UNITED STATES PATENT AND TRADEMARK OFFICE

Office Action Summary

10/501,938

SEVERINI, JOSEPH

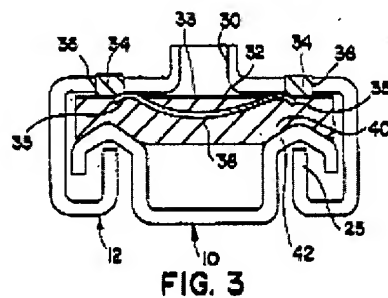
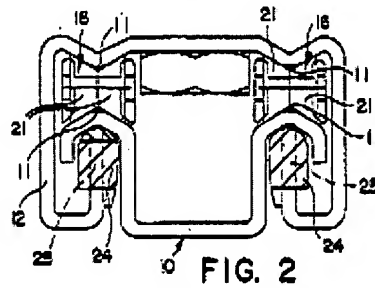
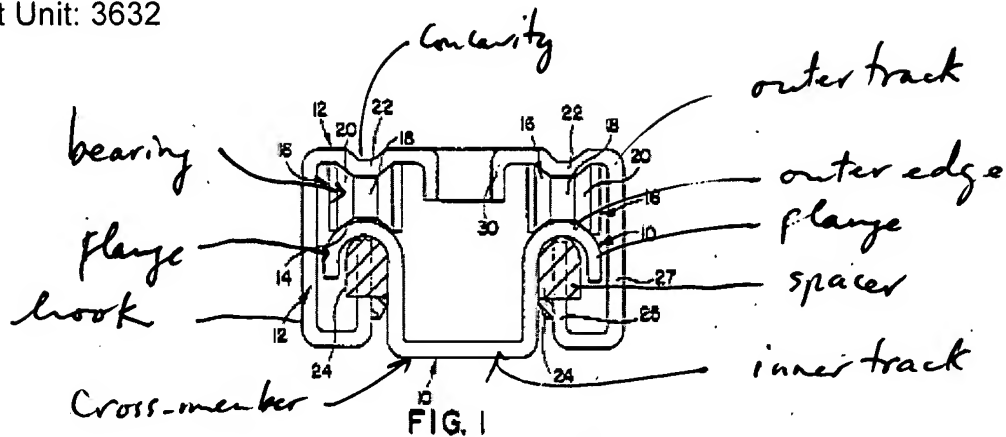
Brandoli et al. discloses the inner track fixedly secured to the floor of vehicle and having a convex bearing surface (see attached figure) but does not disclose expressly the bearing surface is flattened bearing surface.

As to claim 2, wherein said inner track includes two upright sides (see attached figure) and a cross member extending laterally there between to define a U-shaped channel, said sides each having a distal end opposite said cross member.

As to claim 5, wherein said inner track includes an outer wall extending substantially perpendicularly from each of said outer edges to define a flange (see attached figure).

As to claim 7, wherein said outer track includes two upright sides and a base (see attached) extending laterally between said sides to define a U-shaped cross section, said sides of said outer track each including a distal end.

As to claim 8, wherein said base of said outer track includes a concavity (see attached figure) formed therein, said concavity protruding toward said inner track to define said arcuate bearing surface opposing said flattened bearing surface.
